BCA ASSESSMENT REPORT

230 Martin Road, Badgerys Creek NSW 2555

Project Number: 118326

Revision: 4.2

Figure 3 - Exits Warehouse 1

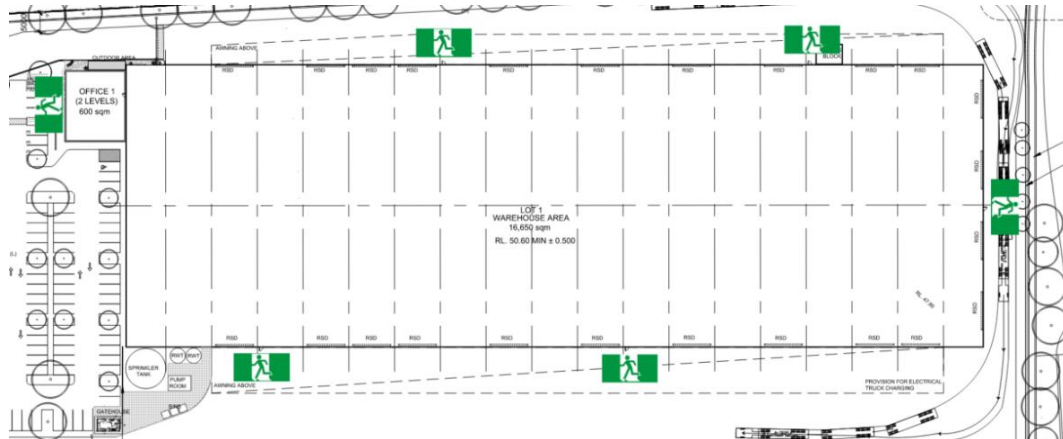
The following points in the building have been considered as the exits:
